## 4 Masterplan & Public Realm

# 6 Comparison Drawings

The following pages contain a series of comparison drawings to allow the amended design changes to be reviewed directly alongside the original approved planning drawings.

6.2.3 Upper Ground Floor Plan

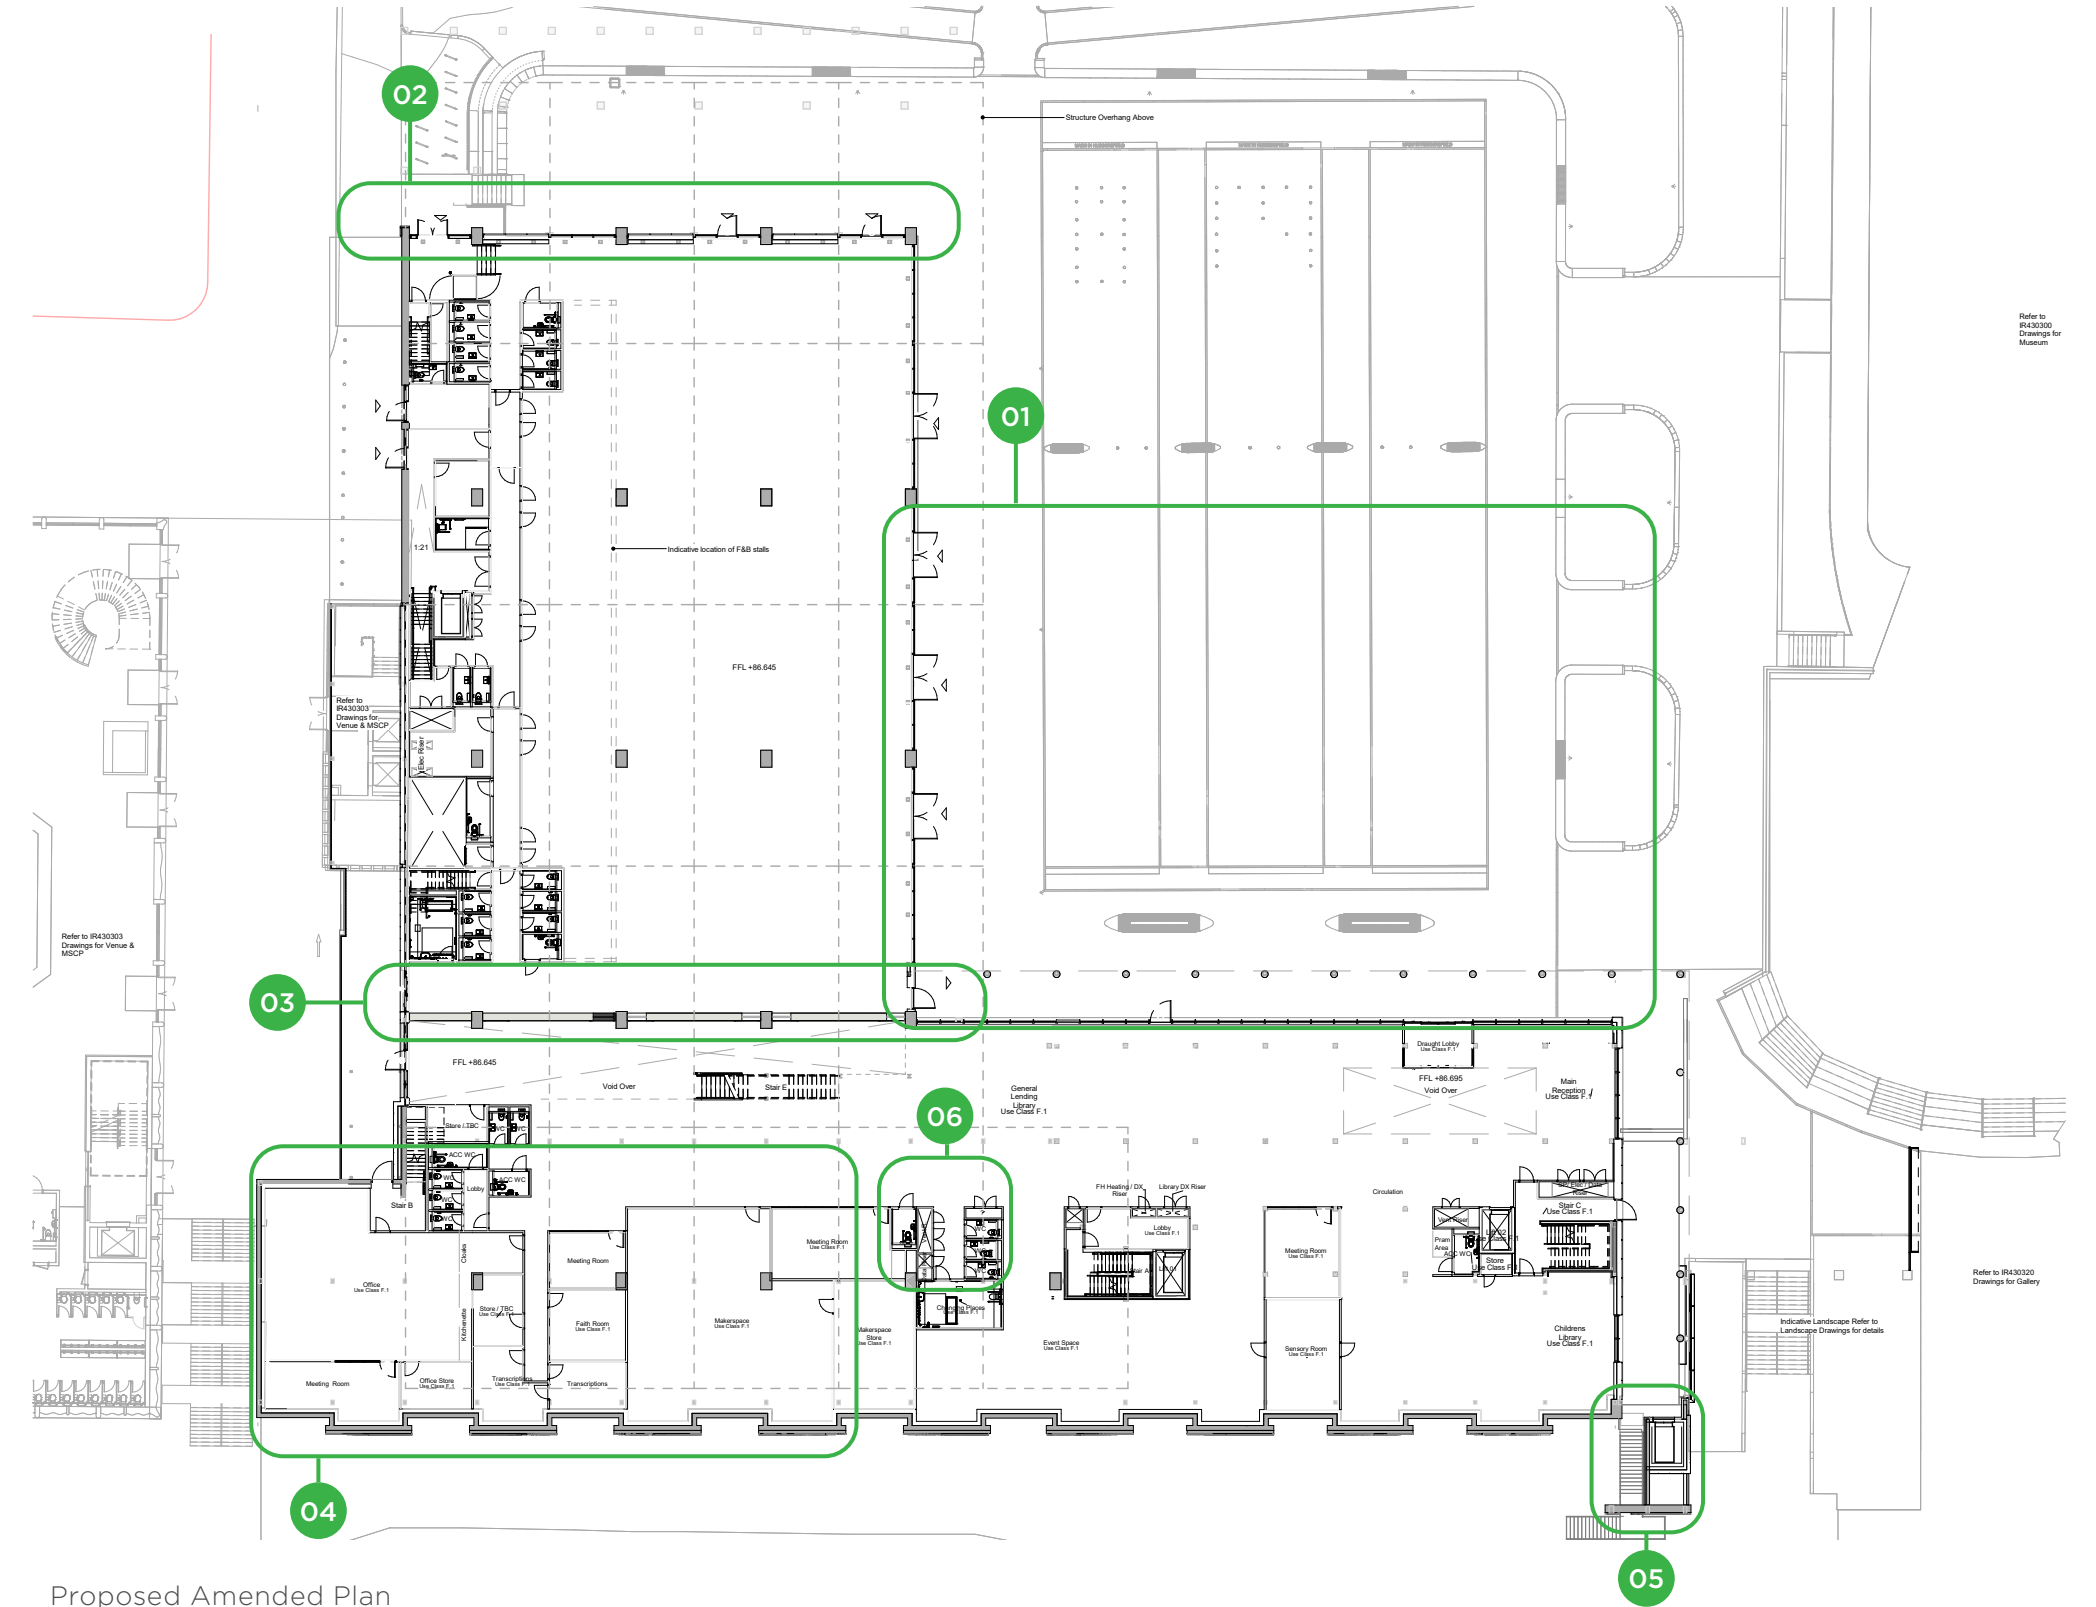
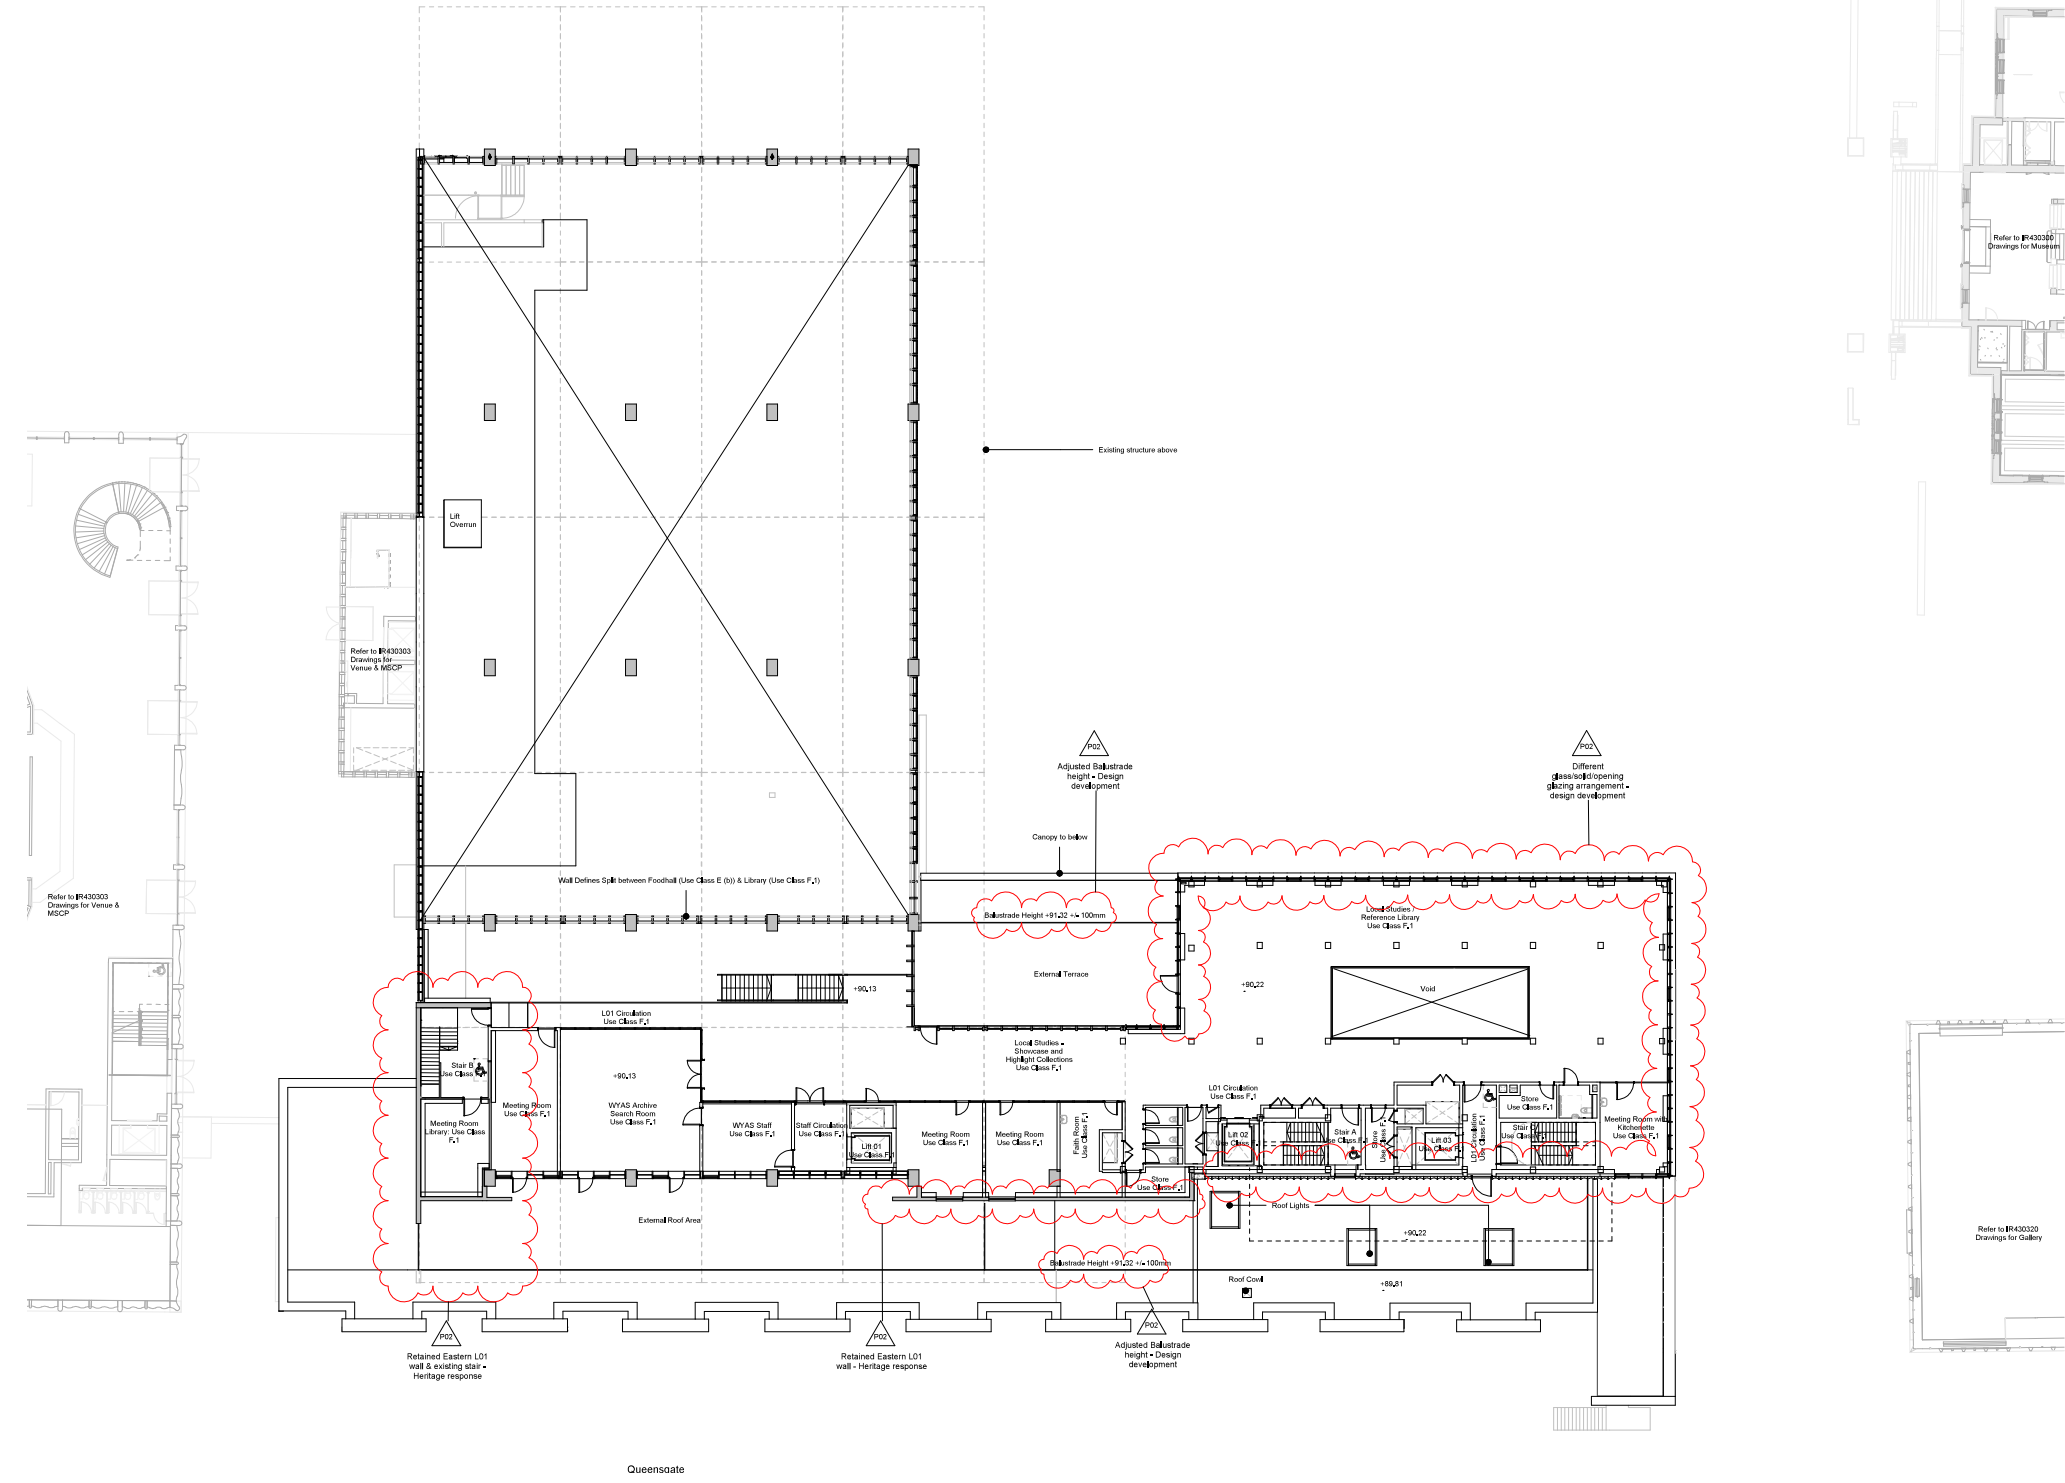
- 01 Omission of water features and restriction on loading (due to retention of existing structure below).
- 02 Introduction of solid cladding to west elevation of Food Hall.
- 03 Introduction of solid wall with fire rated windows instead of fire rated curtain wall glazing.
- 04 Relocation of Library office accommodation to make space for facilities from lower to upper ground floor.
- 05 Relocation of lift to avoid clash with existing below ground sub-structure.
- 06 Omission of one internal lift in library.
